APPLICATION NO.	FILING DATE	FIRST NAMED INVENTOR	ATTORNEY DOCKET NO.	CONFIRMATION NO.
10/711,390	09/15/2004	Cheng-Hsiung Chen	NAUP0527USA	5389
27765	7590	01/12/2006	EXAMINER	
NORTH AMERICA INTELLECTUAL PROPERTY CORPORATION P.O. BOX 506 MERRIFIELD, VA 22116			HO, TU TU V	
			ART UNIT	PAPER NUMBER
			2818

Office Action Summary	Application No.	Applicant(s)	
	10/711,390	CHEN ET AL.	
	Examiner	Art Unit	
	Tu-Tu Ho	2818

DETAILED ACTION

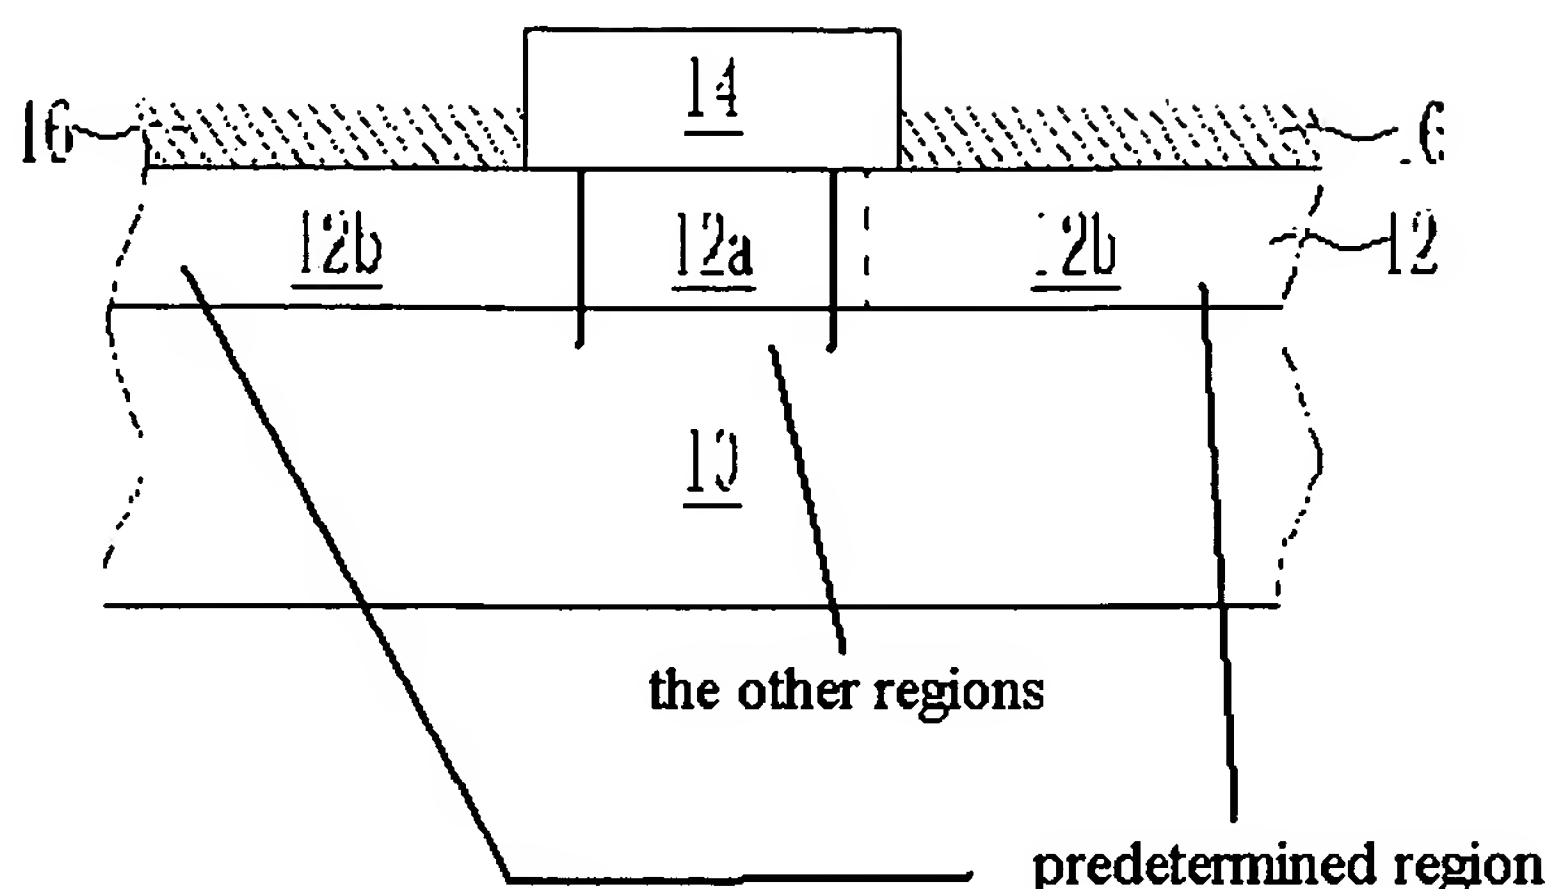
5. **Claim 7** recites:

As such, the semiconductor layer is generally indicated at 12b/12a/12b (Fig. 1 or Fig. 4 of the present application), the high resistance region is generally indicated at 12a, the low resistance region is generally indicated at 12b, “the other regions” is generally indicated at “the other regions” of Fig. 4 of the present application, reproduced above or in a previous page, and the “predetermined region” is generally indicated at “predetermined region”; and as such, it is clear that the claim does not require that the “higher doping concentration” is present in all of the predetermined region, because the predetermined region overlaps portion of the high resistance region (12a, which has a lower doping concentration, as is known in the art and as disclosed by Applicant) adjacent to the junction between the low resistance region (12b) and the high resistance region (12a).
